September 26, 2024

IDEA Public Schools - San Antonio Electrical and Lighting Upgrades IDEA Carver

## ADDENDUM NO. 2

01 ELECTRICAL SITE PLAN  
 SCALE : 1" = 20'

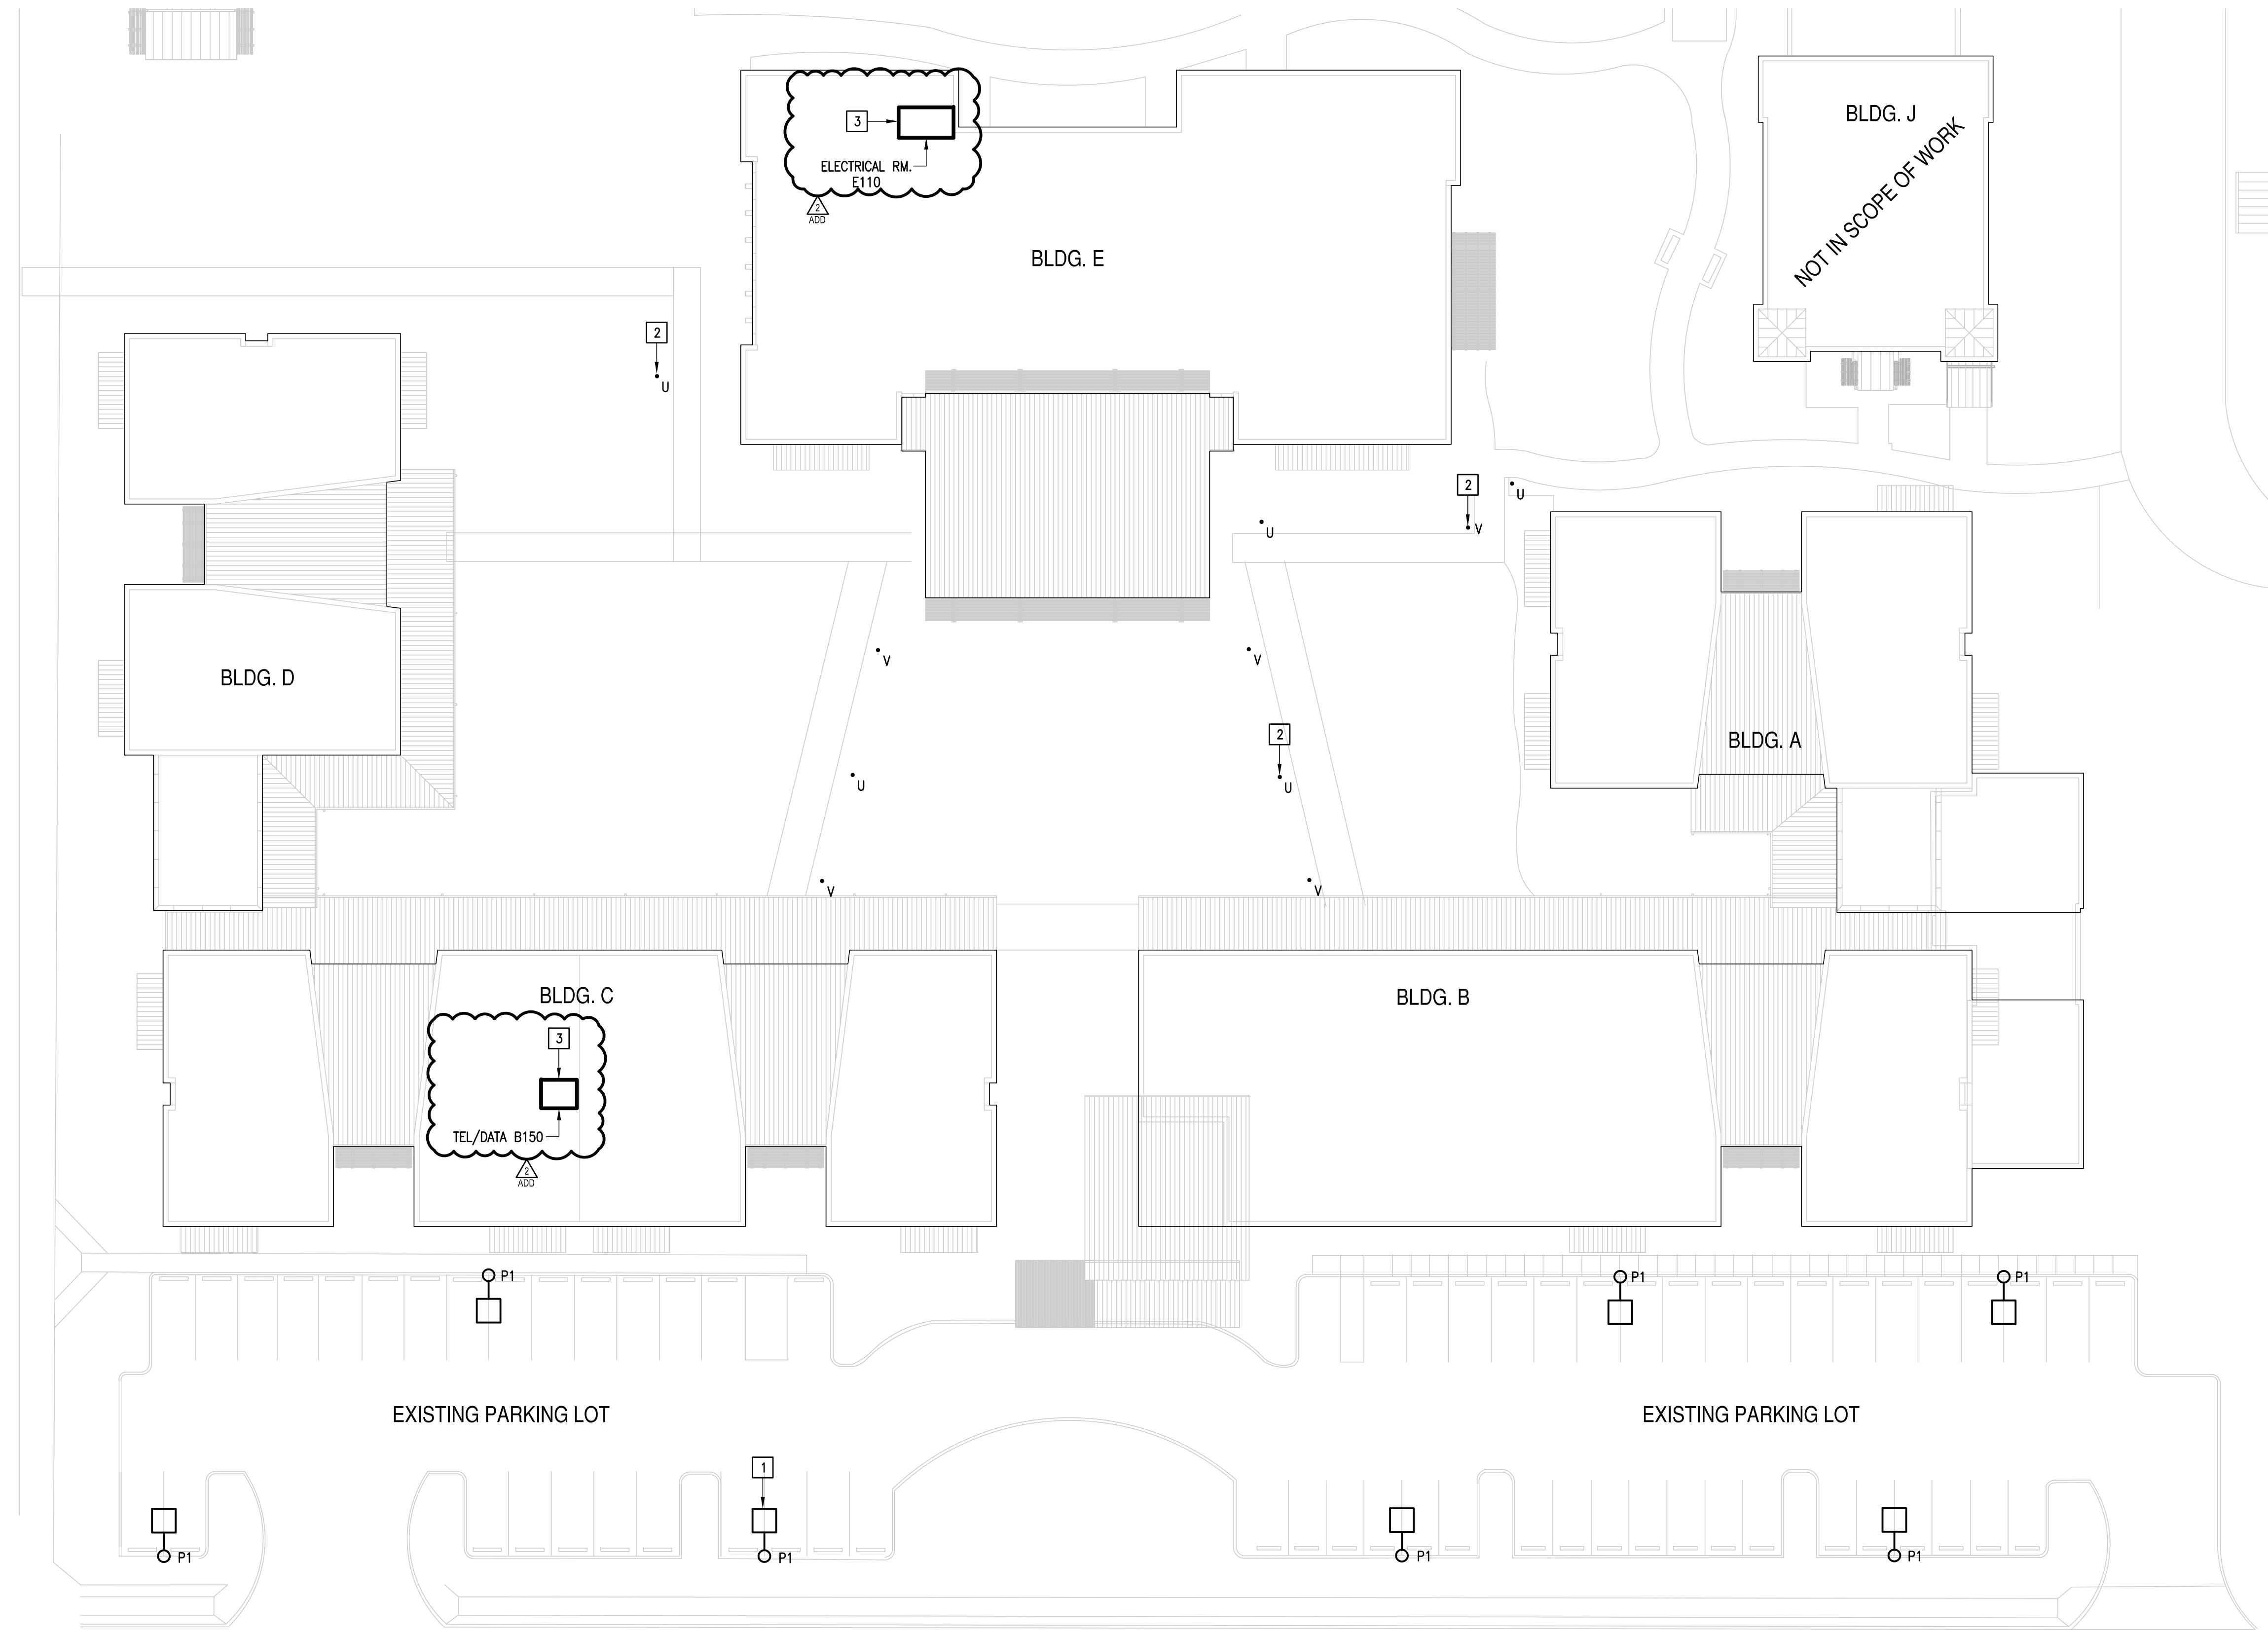
- 1) Sheet ES1.01:
  - a) Revised Keyed Notes: See attached sheet.

- 1 ALTERNATE#2: DISCONNECT AND REMOVE EXISTING LIGHT POLE INCLUDING WIRING. PROVIDE NEW SOLAR LIGHT POLE AS SCHEDULE - TYPICAL.
- 2 ALTERNATE#1: PROVIDE NEW LED BULB LIGHT AS SCHEDULE - TYPICAL.
- 3 ALTERNATE#3: PROVIDE LIGHTING CONTACTOR. PROVIDE LUTRON RELAY POWER PAK AND WIRELESS SWITCH FOR TIME CONTROL AND OVERRIDE FOR EACH. FOR EXTERIOR LIGHTING CONTACTOR OVERRIDE - SEE DETAIL.

IDEA CARVER  
 01 DEMOLITION - LIGHTING PLAN (BUILDING E)  
 SCALE: 1/8" = 1'-0"

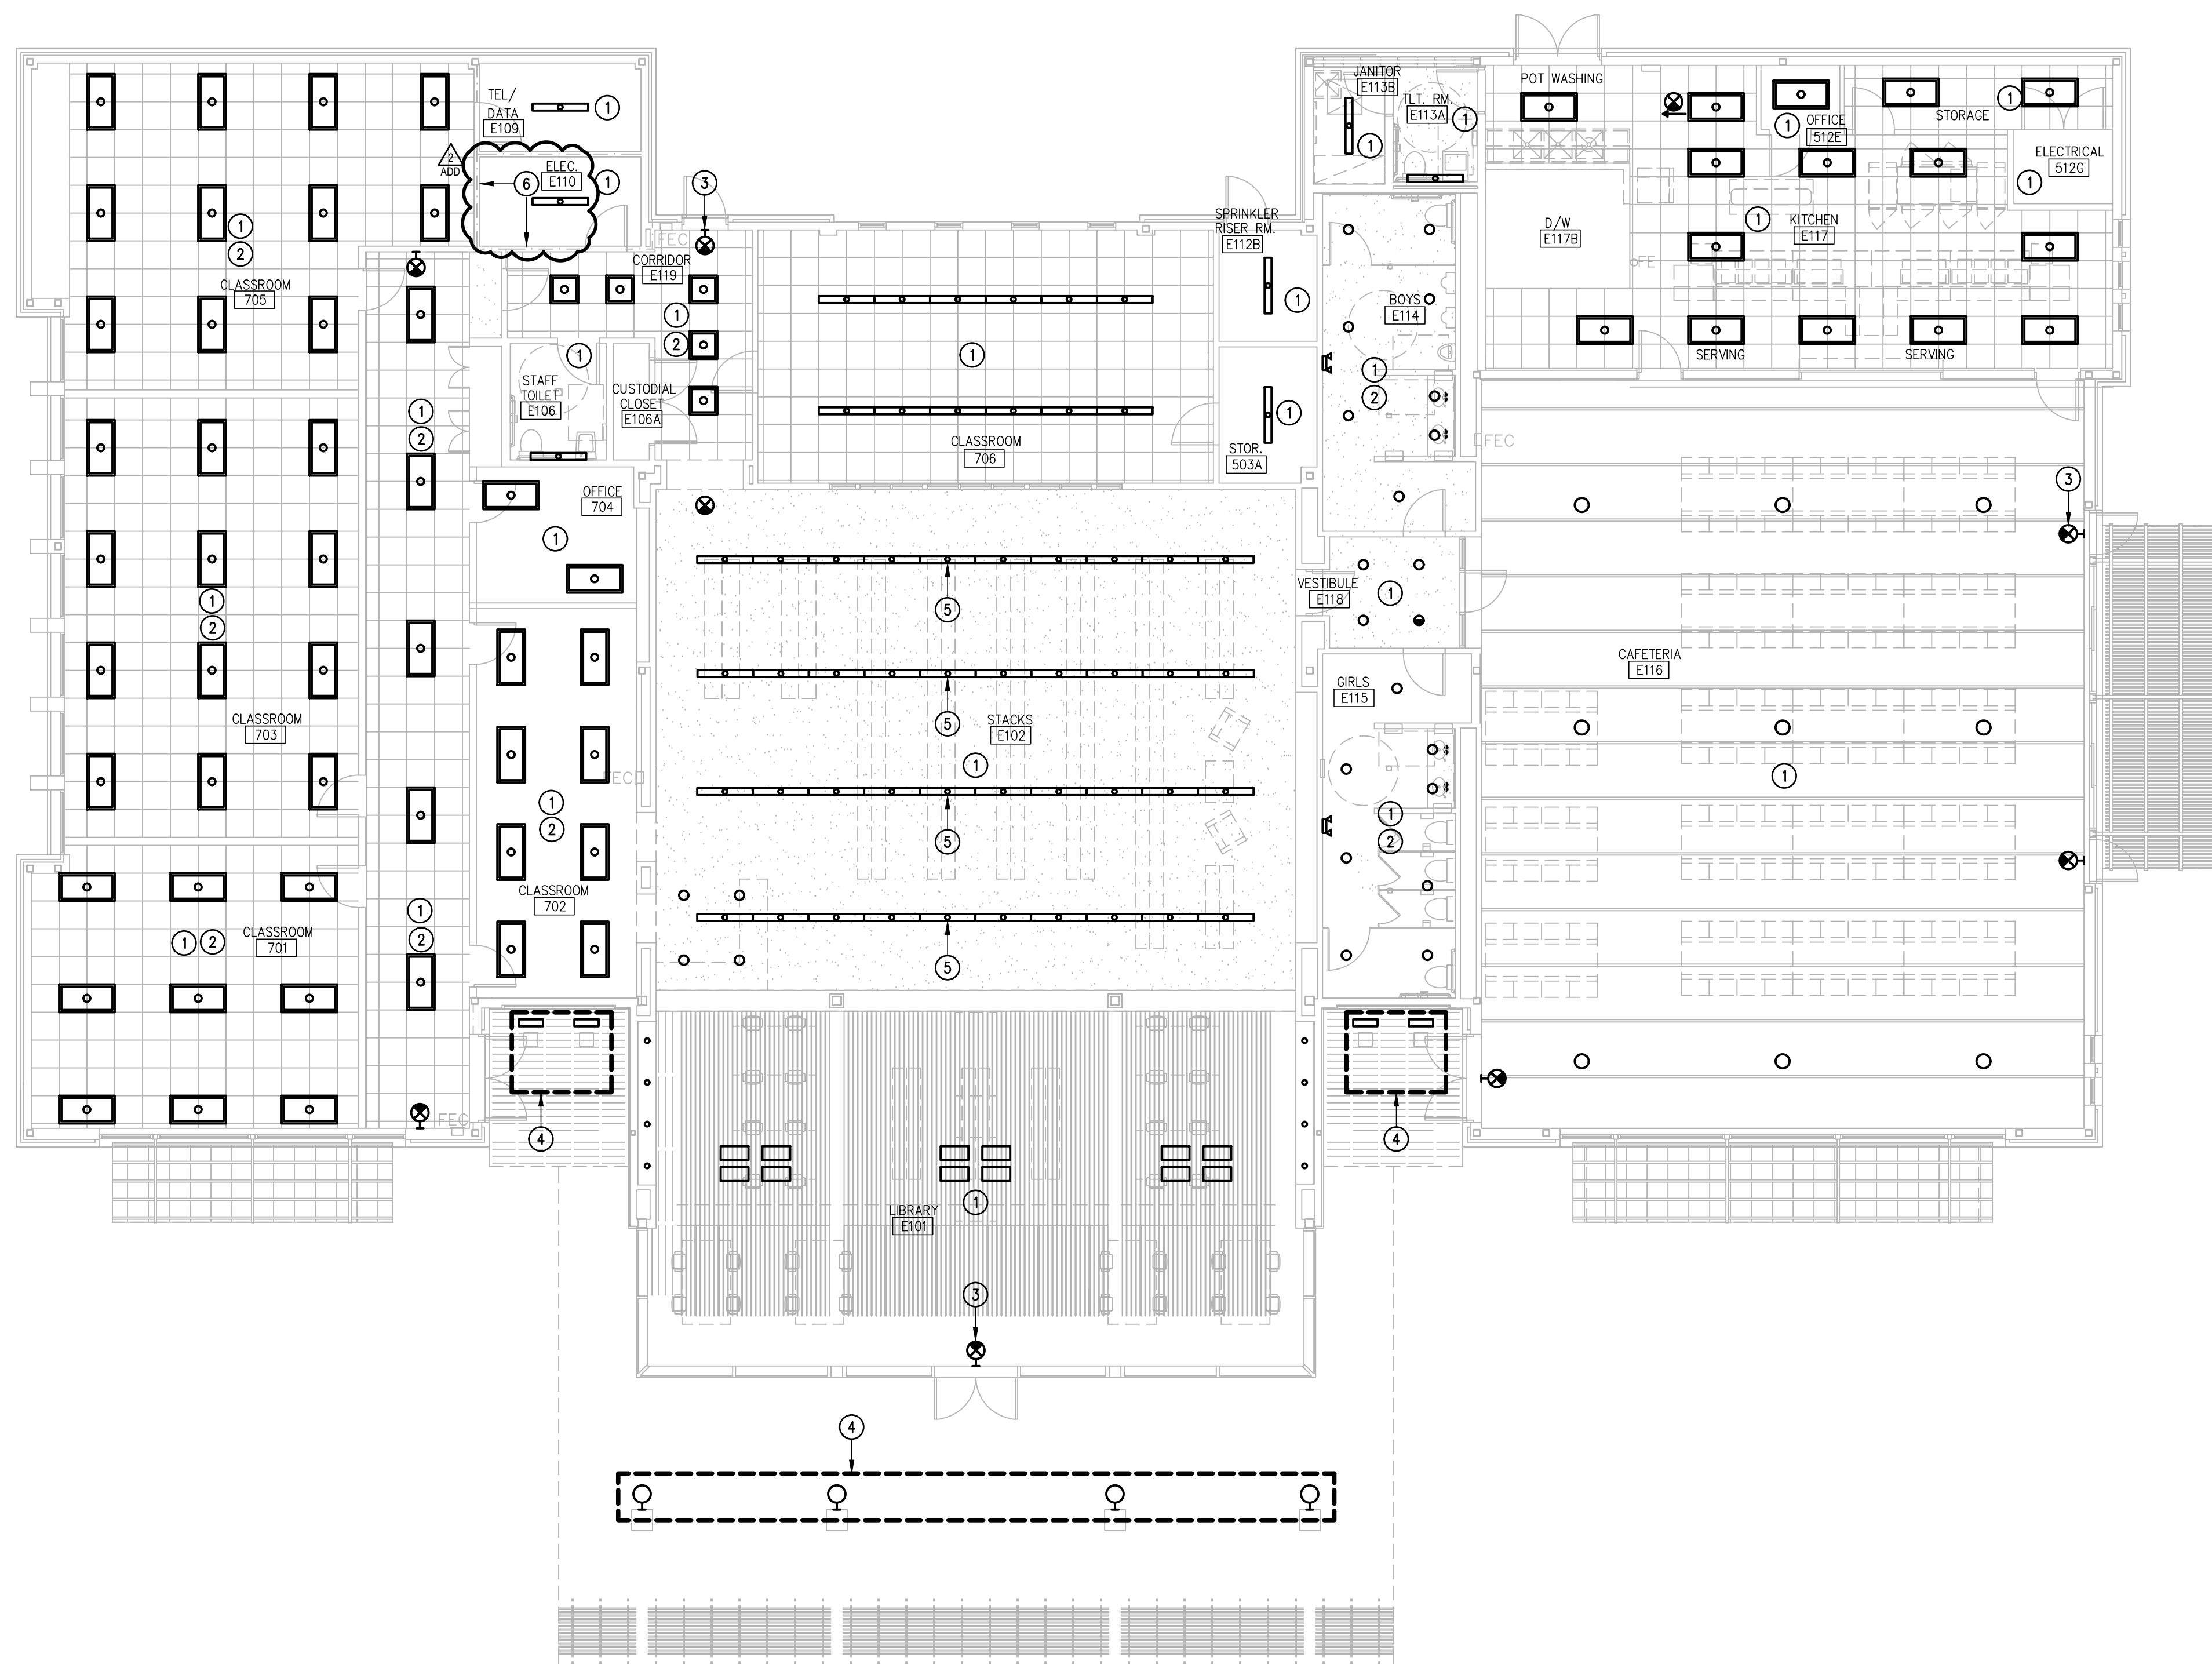
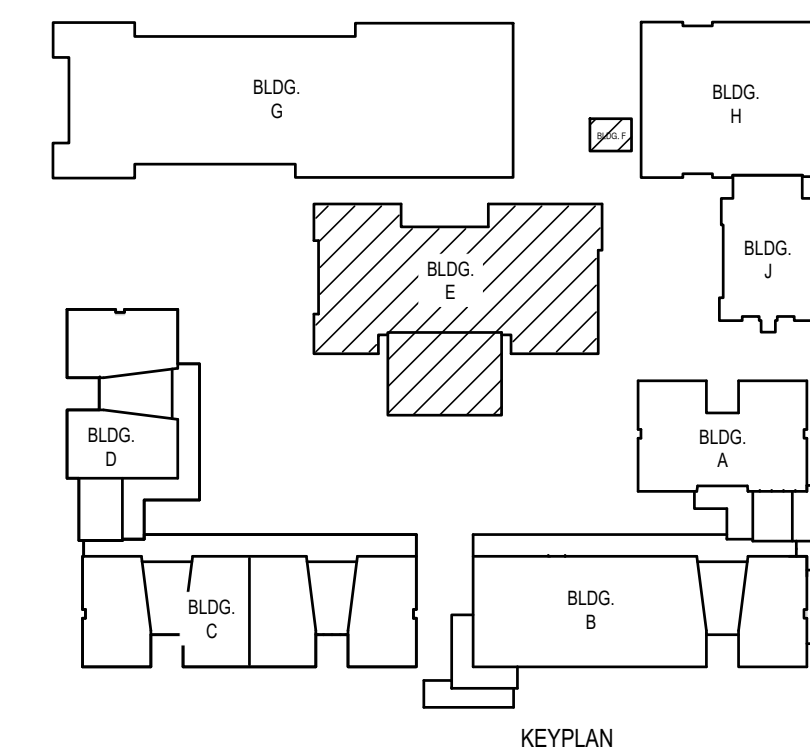
- 3) Sheet E6.01:
  - a) Revised Demolition- Lighting Plan (Building E): See attached sheet.

- 1 DISCONNECT AND REMOVE EXISTING LIGHTING FIXTURE, LIGHTING SWITCHES AND EMERGENCY LIGHT FIXTURE FOR REMOVAL - TYPICAL.
- 2 DISCONNECT AND REMOVE EXISTING OCCUPANCY SENSOR AND ASSOCIATED POWER PACK.
- 3 DISCONNECT AND REMOVE EXISTING EXIT LIGHT FIXTURE - TYPICAL.
- 4 ALTERNATE#1: DISCONNECT AND REMOVE EXISTING EXTERIOR LIGHTING FIXTURE FOR REPLACEMENT - TYPICAL.
- 5 DISCONNECT AND REMOVE FLUORESCENT BALLAST. NEW LED LAMPS TO BE CONNECTED LINE VOLTAGE.
- 6 DISCONNECT AND REMOVE EXISTING REMOTE BALLAST LOCATED ON SOUTH AND WEST WALLS. PROVIDE A J-BOX, WIRING AND CONDUIT FOR COMPLETING CIRCUIT. FIELD CONFIRM CORRESPONDING LIGHT FIXTURES PRIOR TO REMOVAL.

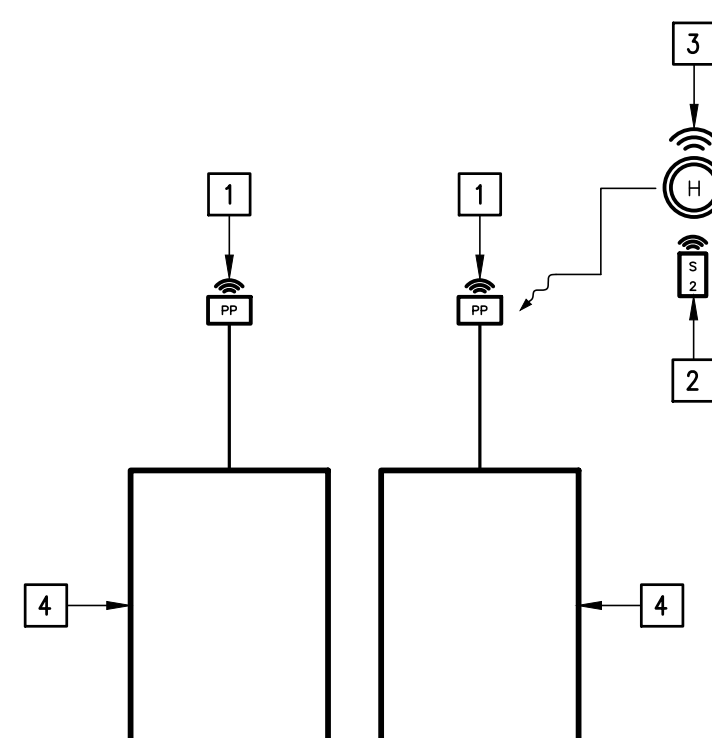
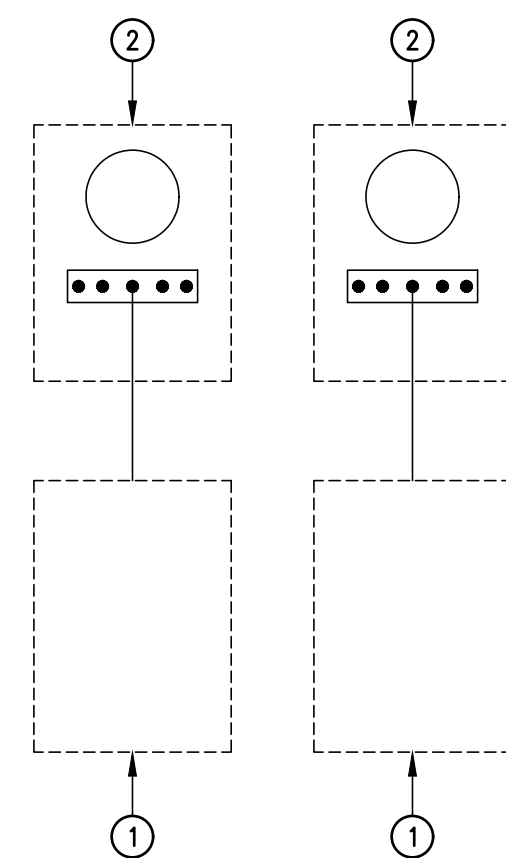
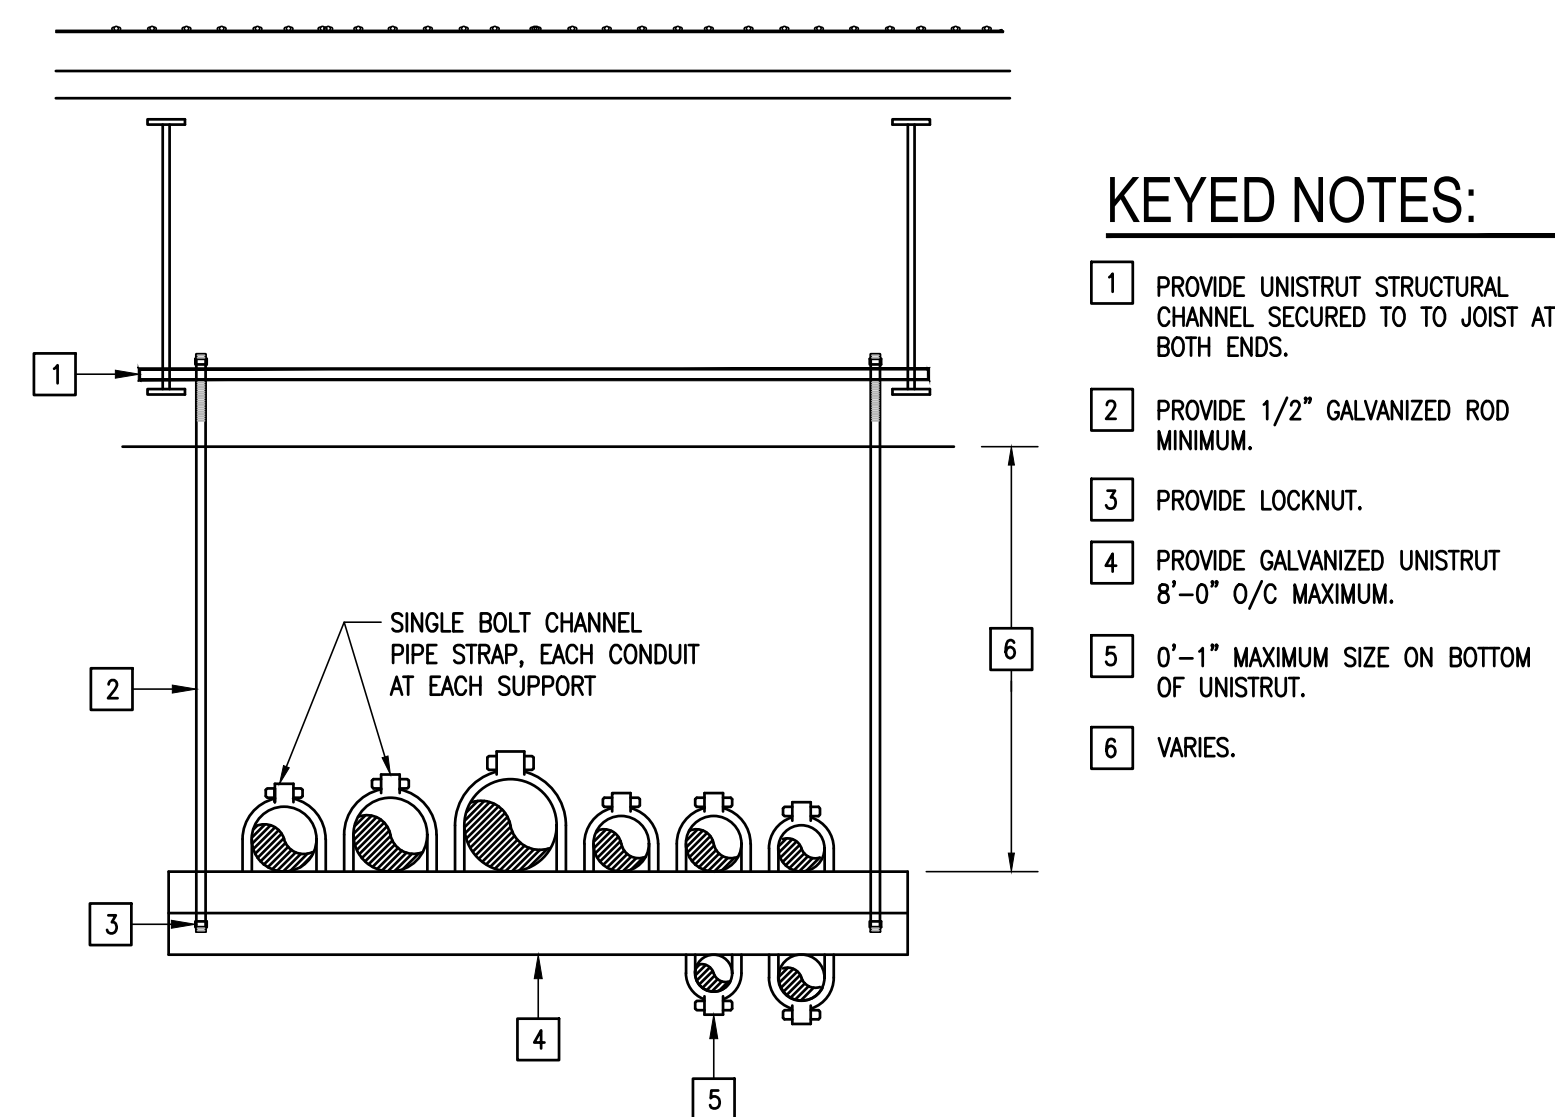
- 1) Do the plans show how exterior lighting is to be controlled?  
**Response: Exterior lighting controls for building "B", "C" & "E" are to be per detail #04/E8.01.**
- 2) Would the existing electrical outlets be required to be controlled per IECC?  
**Response: Per the City of San Antonio plans examiner department existing electrical outlets are not required to comply with the automatic control of the IECC.**

- 4) Sheet E8.01:
  - a) Revised Electrical Details: See attached sheet.

1. PROVIDE POWER PACK FOR CONTROLLING LIGHTING CONTACTOR.
2. PROVIDE LUTRON WIRELESS PICO SWITCH FOR LIGHTING CONTACTOR OVERRIDE.
3. TIME SCHEDULES FOR CONTACTORS VIA LUTRON VIVE HUB.
4. PROVIDE NEW 277V, 30A, 6-POLE, ELECTRONICALLY HELD LIGHTING CONTACTOR. RECONNECT EXISTING BRANCH CIRCUITS.

1. DISCONNECT AND REMOVE EXISTING LIGHTING CONTACTOR TEMPORARILY DISCONNECT EXISTING BRANCH CIRCUITS.
2. DISCONNECT AND REMOVE EXISTING ELECTROMECHANICAL TIME CLOCK ALONG WITH RELATED SUPPORT HARDWARE, RACEWAYS AND WIRING.

- GENERAL UPGRADES NOTES:**
1. QUANTITY OF EXISTING CIRCUITS VARY BY BUILDING FIELD VERIFY.
  2. IF EXISTING BRANCH CIRCUITS DO NOT REACH NEW POINTS OF CONNECTION SPLICE EXISTING WIRING AND PROVIDE NEW WIRING AS NECESSARY. MATCH EXISTING BRANCH CIRCUITS WIRE SIZES.
  3. NEW TIME CONTROL TO BE VIA LUTRON VIVE HUB. COORDINATE SCHEDULES WITH CAMPUS FACILITY MANAGER (FM).
